<b>Case number:</b>	10858ABC-10
<b>Address:</b>	8936 and 8946 Lyndale Avenue
<b>Application type:</b>	1) Rezone from B-2, General Commercial to Becky-2 (PD), General Commercial (Planned Development) (Case 10858A-10); 2) Preliminary and Final Development Plan for a 12,900 square foot retail building (CVS Pharmacy) (Case 10858BC-10)
<b>Applicant:</b>	Velmeir Companies

CITY OF BLOOMINGTON  
Division of City Planning  
**REPORT TO THE PLANNING COMMISSION**  
June 24, 2010

**Re: CVS @ NWC Lyndale & 90<sup>th</sup>  
Development Review Application**

LANDSCAPE PLAN

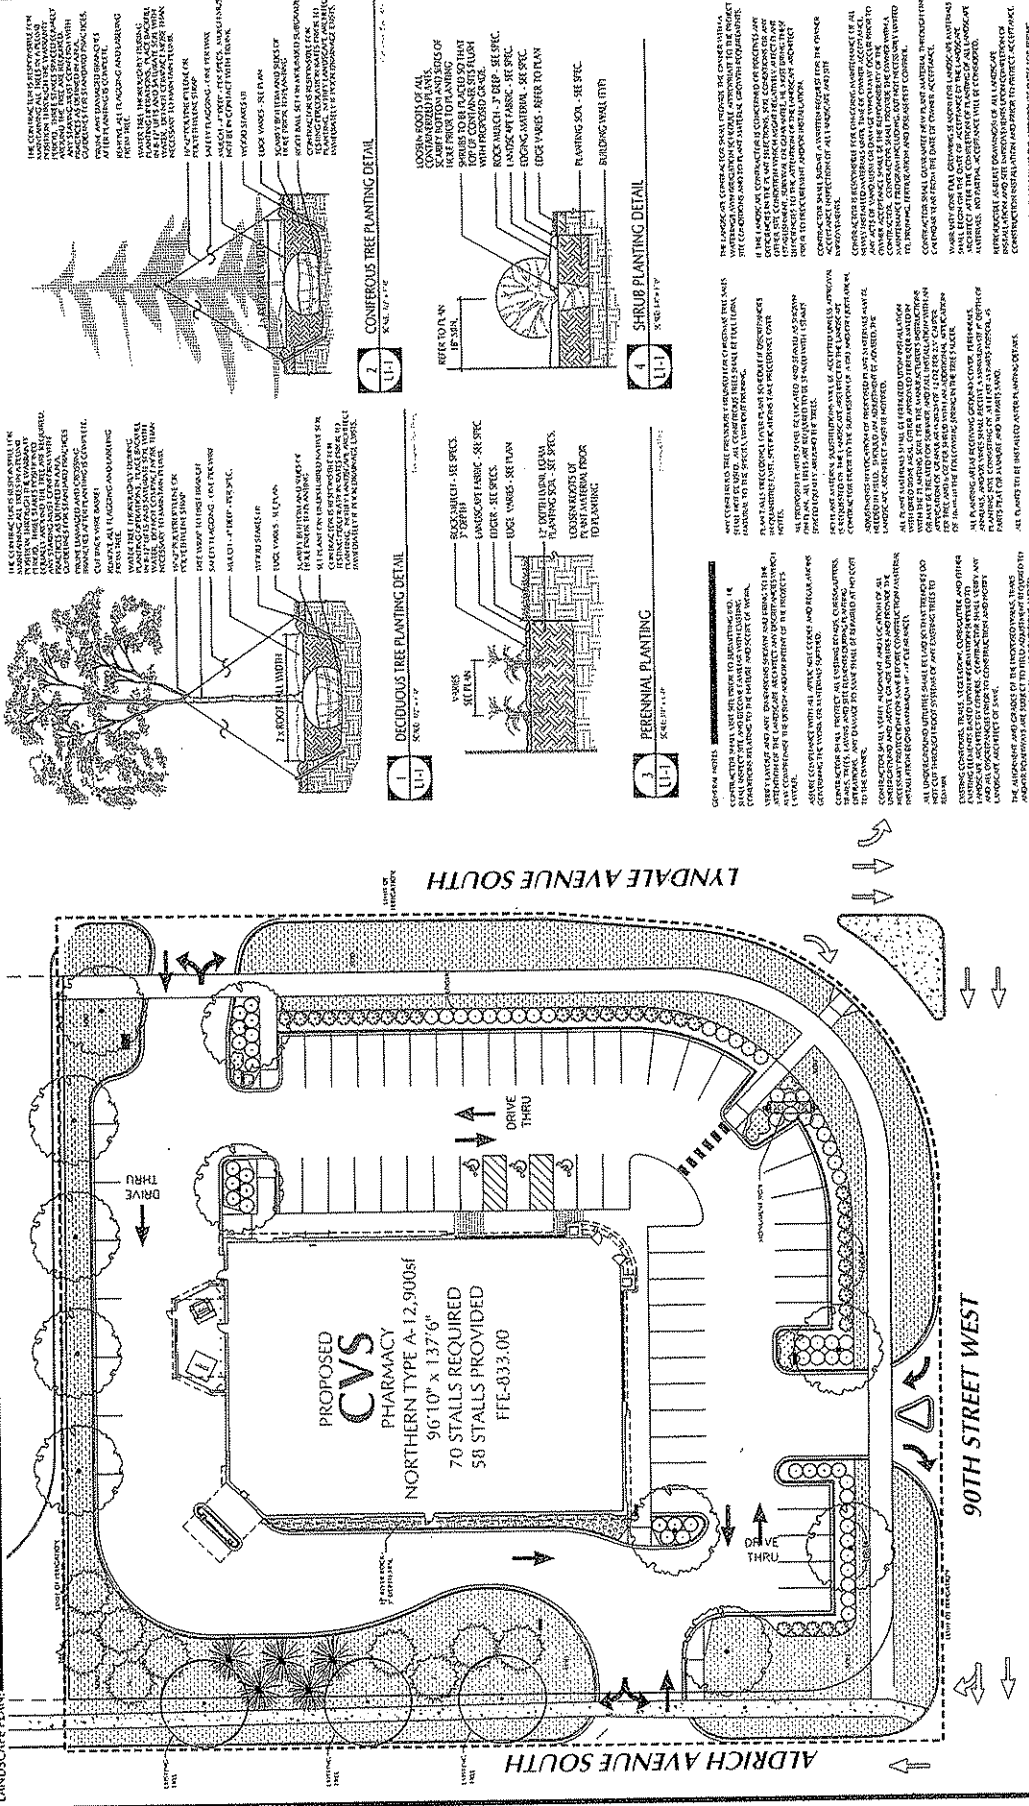
The proposed landscape plan provides Code complying amount of plant materials although is not Code compliance. A combination of up to a 4-foot berm and landscaping will provide code complying screening between the residential use to the west and the proposed development. The three foot required screen along Lyndale Avenue and West 90<sup>th</sup> Street are provided by landscape materials. The applicant does not provide required landscaping in three of the parking lot islands. In addition, several trees are proposed in the sidewalk easement along Aldrich Avenue. These trees shall be relocated out of the easement.

The City code requires all elements of the drive through service area, including but not limited to menu boards, order stations, teller windows, and vehicle lights from the stacking lanes, must be screened from view of residential properties zoned R-1, R-1A, RS-1, R-4, RM-12, RM-24 or RM-50 located within 300 feet. Screening must comply with the perimeter screening standards specified in Section 19.52(d). This requires a five foot screen solid screen on the north and west sides of the drive through. This has not been provided.

- 8) Landscape plan be approved by the Planning Manager and landscape bond be filed (Sec 19.52);
- 9) All rooftop equipment be fully screened (Sec. 19.52.01);
